Hourly Chime

Regarding Hourly Chime for Digital Clock article in May '85 issue. (a) can I use 1Hz output of 5387 IC (colon display) instead of IC4, and (b) can this circuit be used for alarm? If so, how?

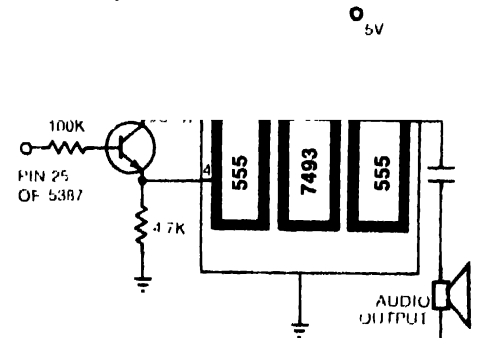
Let me offer some alternatives which I hope will provide useful stimulation to further thinking on this subject.

The sketch below shows the schematics of the ideas, the original circuit of chime can remain as published—except for the wiring of the reset terminals of ICs 4, 5 and 6. For deriving hourly pulses, the decoder suggested by me utilises the fact that in a digital clock the display indicating tens of minutes has segments b and e both off at the display of '5'. One of them or both are high in all other

cases. As such at the striking of an hour when the minutes change from '59' to '00', the 'b OR e' becomes high and this can supply a negative going pulse each hour. For this purpose a simple decoder consisting of two diodes, one transistor, four resistances and a capacitor is suggested, which is self-explanatory.

Now unless one plans to have more than one cycle of 7493 for hour striking chimes, the facility of built-in reset terminals of the various ICs can be utilised for controlling the chiming. The 7493 (IC5) resets when both its reset terminals (pins 2 and 3) are brought to high and will start counting only when one of these is brought to ground.

In the proposed circuit the reset terminal of 7493 (pin 3) is wired in such a way that when the counter reaches the count of (binary) 1111 (i.e. when all the outputs of IC5 are high) pin 3 becomes high, in all other cases it is pulled low by appropriate (low) output and diode. Also, when pin 3 (of IC5) is high, the ICs 4 and 6 are disabled by NAND gates B and C wired as NOT gates by bringing down the terminals numbered 4 of these ICs (4 and 6) to ground. When pin 3 of IC5 is low, the ICs 4 and 6 are enabled and the chime works as in the original circuit, and when the output of IC5 reaches the count of (binary) 1111, pin 3 (of IC5) goes high and the chime stops on account of ICs 4 and 6 becoming disabled by their low going reset terminals, and the input to NAND gate D (wired as NOT gate) becomes low making its output high. This gate D helps in maintaining the output of IC5 as this IC is triggered by falling edge only and a high-going pin 14 of IC5 does not matter. This steady state (i.e. ICs 4 and 6 reset and IC5 parked at count 1111) will be maintained till the next hourly negative going pulse is received at the input of NAND gate A, bringing down to earth the pin no. 2 of IC5 momentarily.

As the (reset) pin no. 3 of IC5 was already high and pin 2 also becomes high (even though momentarily) the IC5 resets to the binary output of '0000'. The chime starts

working and once again stops when the output of IC5 reaches the binary count of 1111 waiting for the next hourly pulse to operate it.

The unused input terminal of NAND gate C is to be used for suppressing chiming during displaying of alarm, seconds, sleep etc. The detailed circuit cannot be included here for shortage of space.

I appreciate Mr P. V. Singh's interesting idea. This is one of the possible ways to get the decoded pulse for the hourly strobing signal. It may work. The readers may construct, test and make use of this.
